*Revision updating drainage areas and inlet calculations and utility main alignments

CORLEY FARMS
UNIT 2

CONSTRUCTION PLANS

ULTIMATE MASTER DRAINAGE PLAN

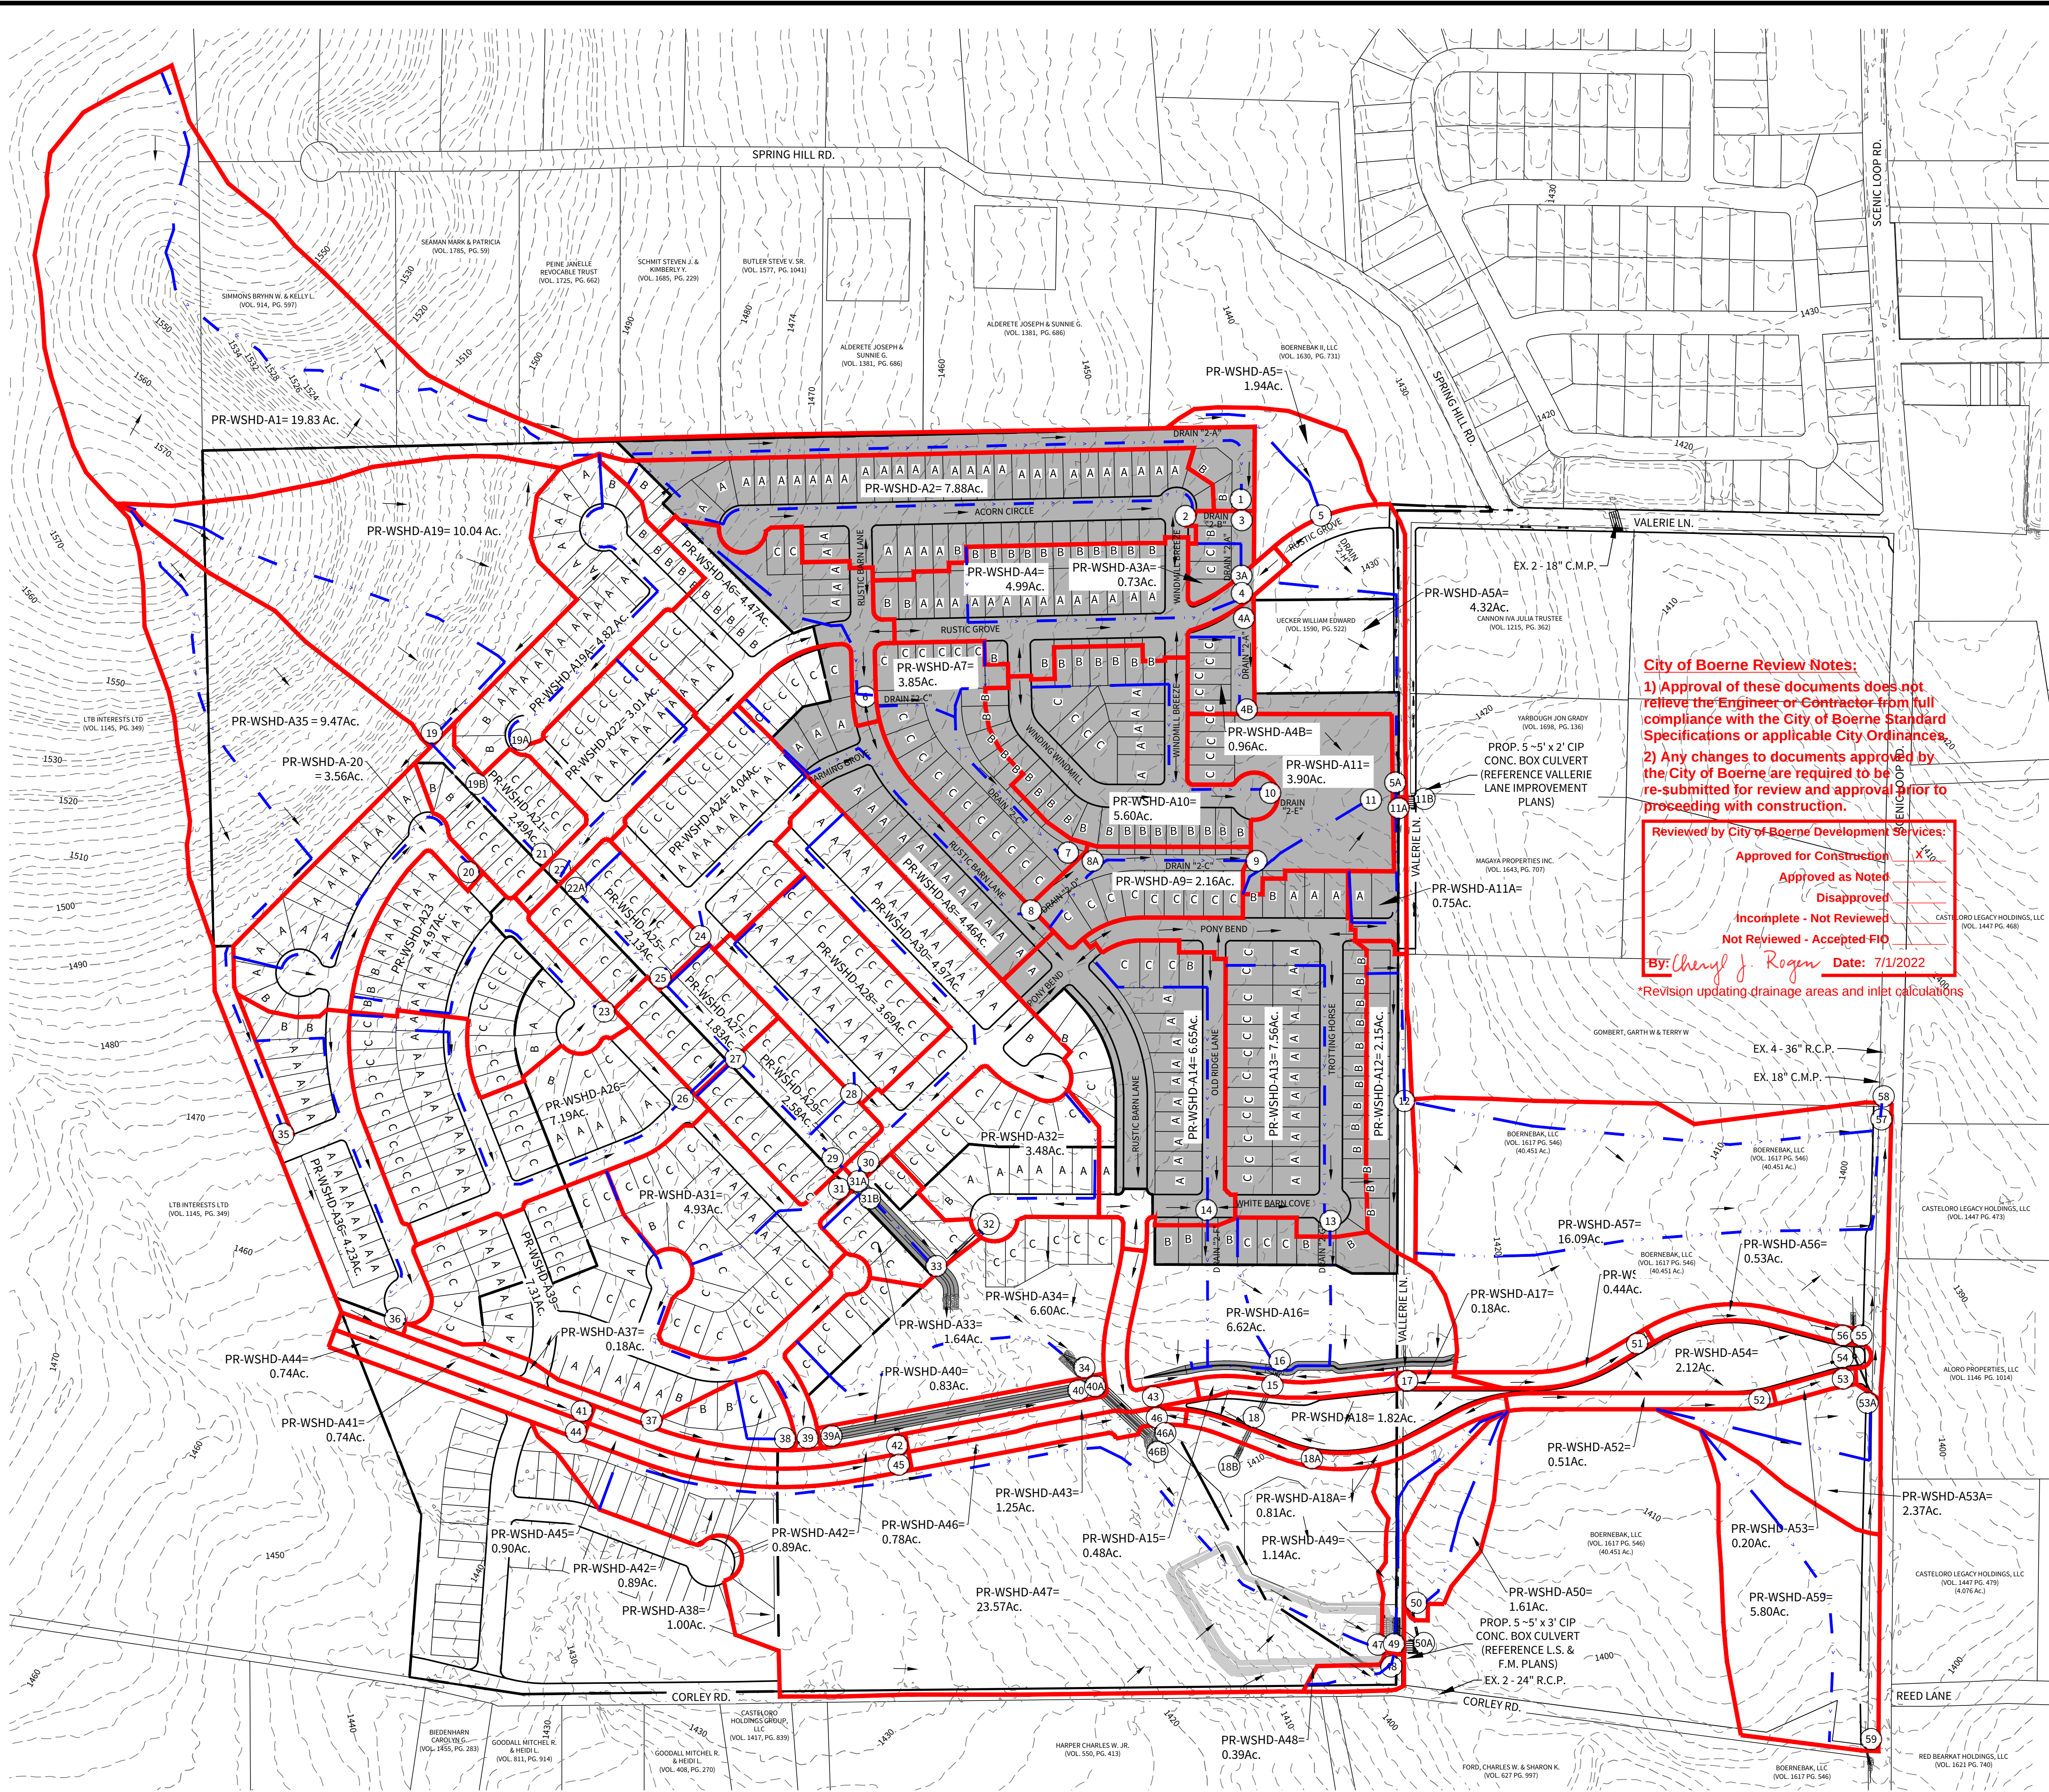
By: Cheryl J. Rogan Date: 7/11/2022
*Revision updating drainage areas and inlet calculations

STREET PLAN & PROFILE - RUSTIC BARN LANE

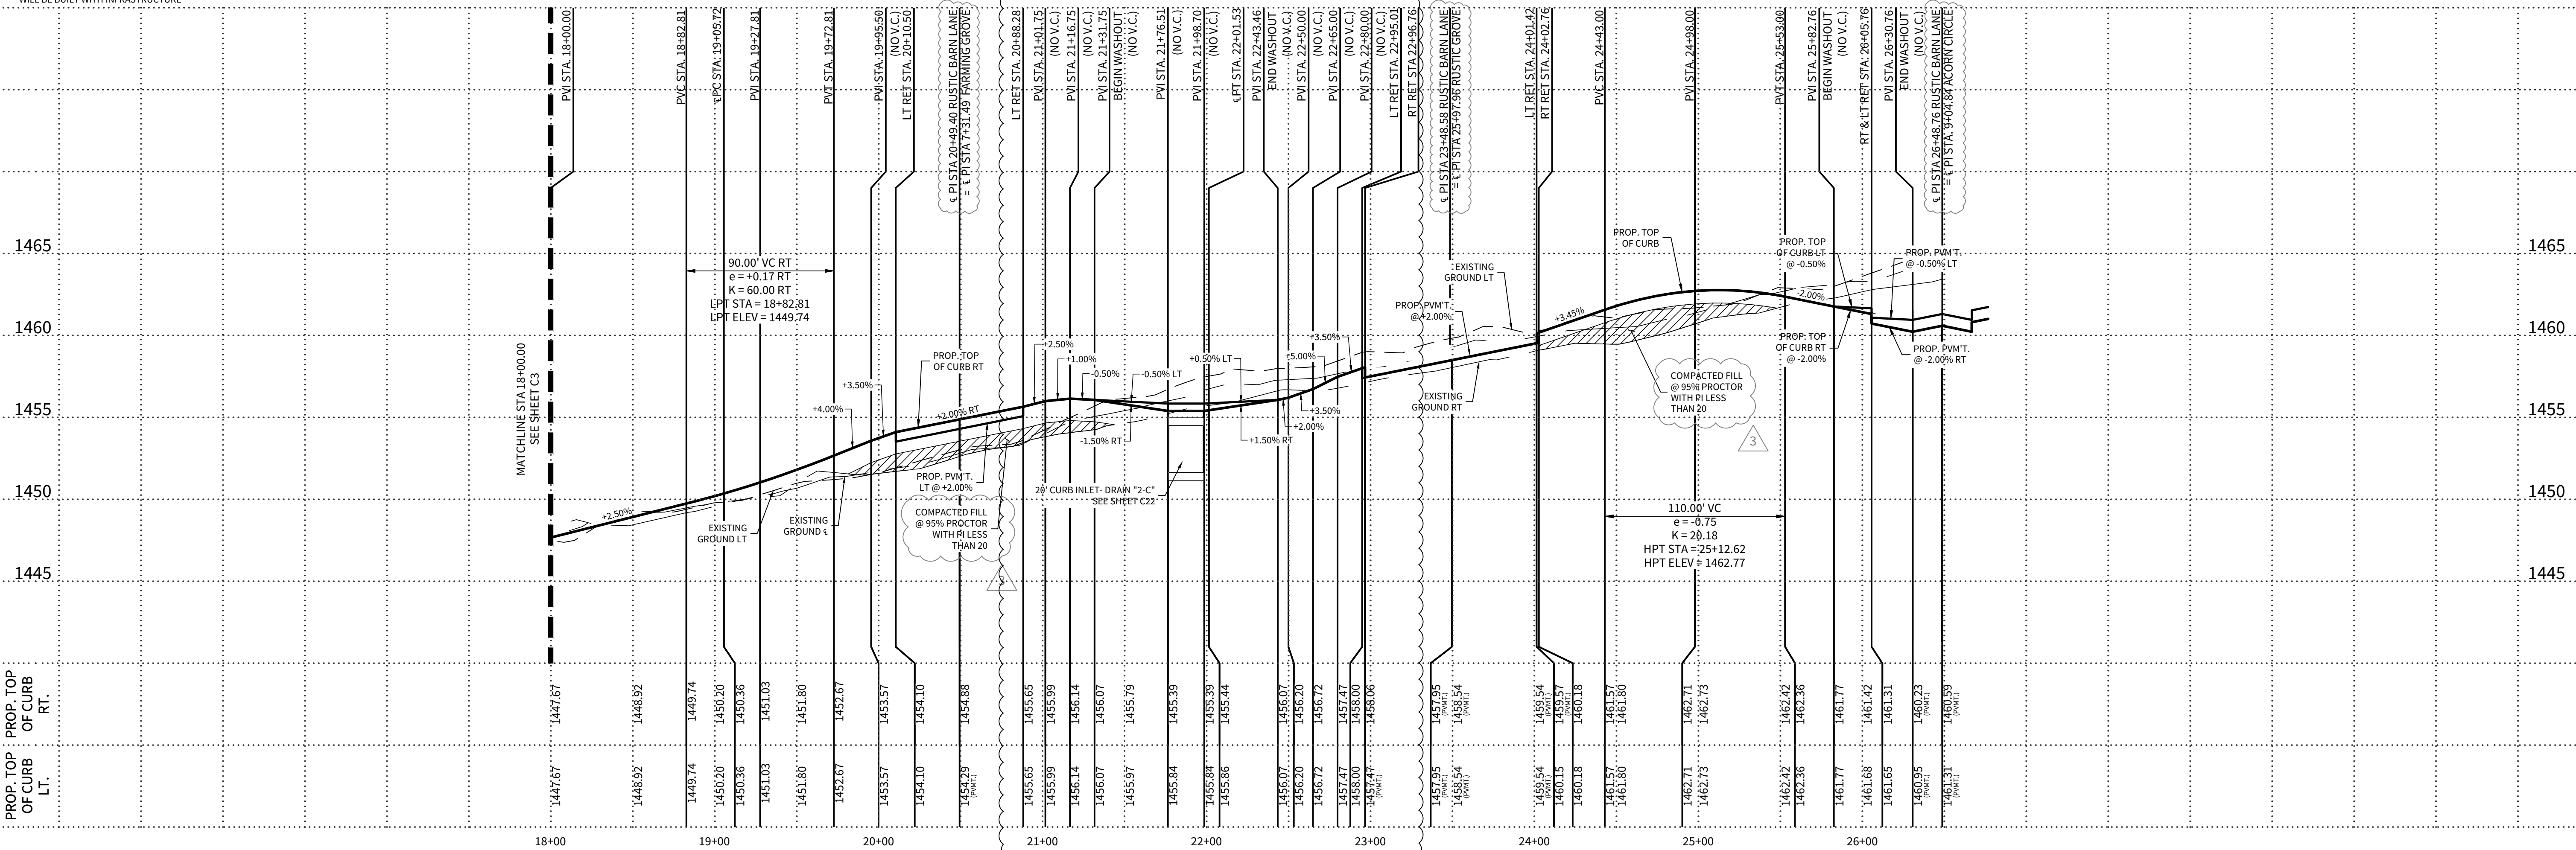
*Revision updating drainage areas and inlet calculations

1. 2021-06-08 - REVISED STREET NAME, ADDED ADA CROSSWALK PAVT., STRIPING.
2. 2021-06-23 - ADDED ADA CROSSWALK PAVT., STRIPING, REVISED STREET NAME.
3. 2021-10-07 - CITY OF BOERNE COMMENTS.
4. 2021-11-12 - ADDED STREET NAMES.
5. 2022-03-04 - CURB INLET UPDATE.
- 6.
- 7.
- 8.
- 9.

DRAIN PLAN & PROFILE - DRAIN '2-C'

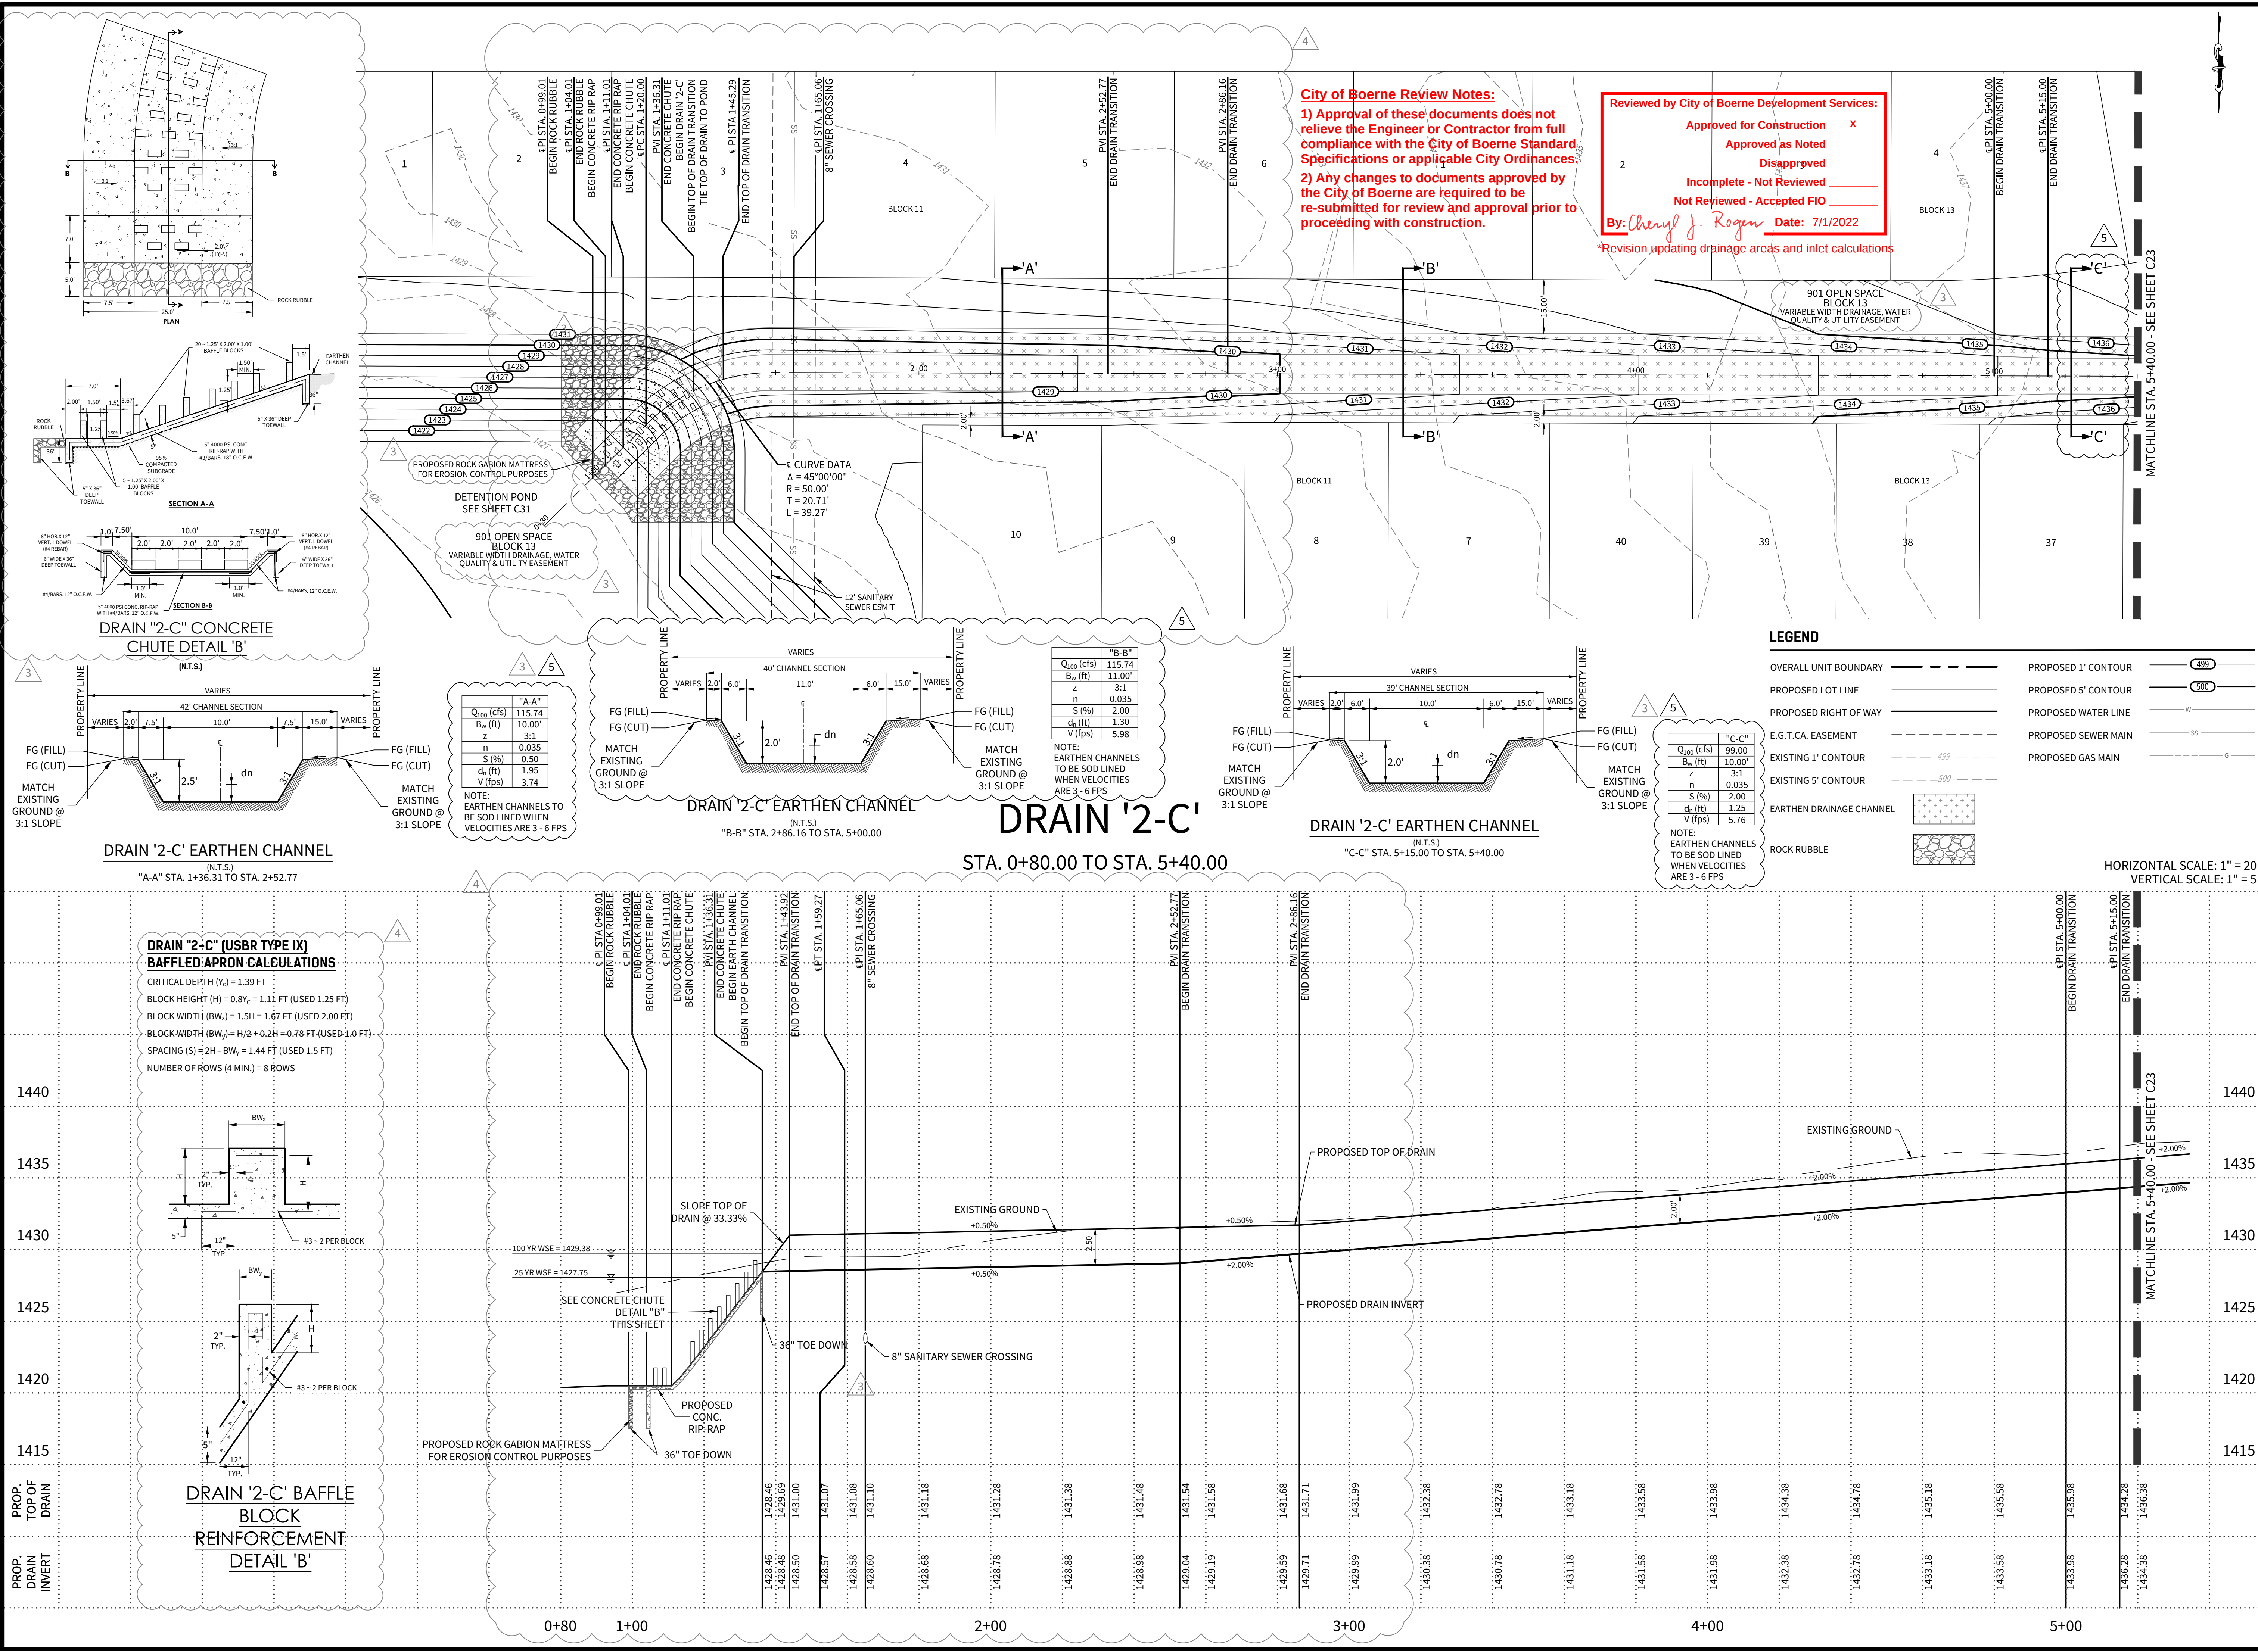
Reviewed by City of Boerne Development Services:
Approved for Construction ☒ X
Approved as Noted ☐
Disapproved ☐
Incomplete - Not Reviewed ☐
Not Reviewed - Accepted FIO ☐
By: Cheryl J. Rogan Date: 7/1/2022
*Revision updating drainage areas and inlet calculations

DATE	03/03/2022
PROJECT NO.	03481.005
DRAWN BY	C3
CHECKED BY	XV/JC/DDC
REVISIONS	1. 2. 3. 2021-10-07 - CITY OF BOERNE COMMENTS 4. 2021-11-12 - INCREASED GABION MATTRESS LIMITS 5. 2022-03-03 - DRAINAGE UPDATES 6. 7. 8. 9.
